SITE INSPECTION NOTES

Church Name: St Tewdric's Church, Mathern

Project Ref: 23-1023

Date: 23rd June 2025

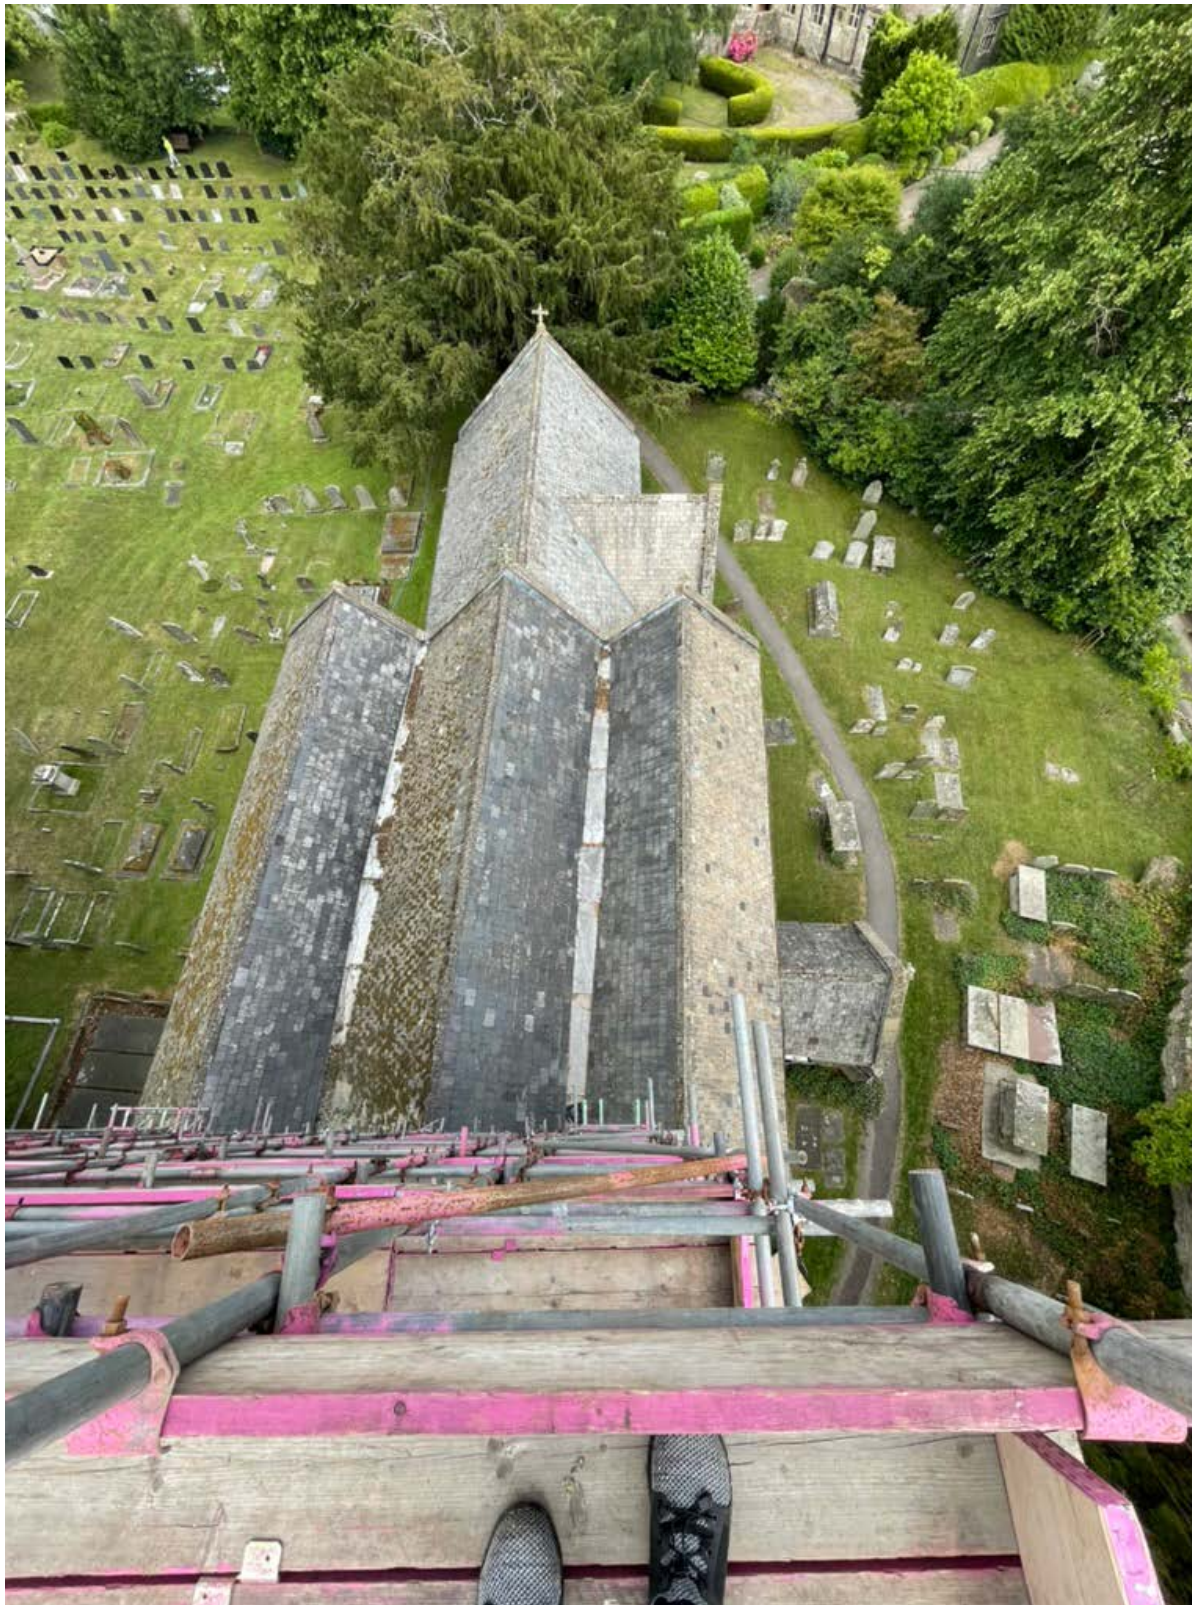
Image 1: North elevation of the tower to the sting course below the ringing chamber. A small stone indent is to be included on the list.

Image 2: Scaffolding ladders have been left on the roof. Small number of slates to be repaired to this area, and to the wider roof (where access permits). Large amount of build-up of moss in the lead box gutters, this has formed a blanket towards the west discharge point. The lead is to be inspected once the materials have been removed.

Image 3: The process of lime mortar repointing requires the lime to be tended and is not a quick process and is influenced by the weather conditions. The image above provides an example of lime most recently applied within the joint. Once this is ready and 'leather-hard' it will be knocked-back/tamped with a churn brush to expose the aggregate. Please note, this is not the final finish!
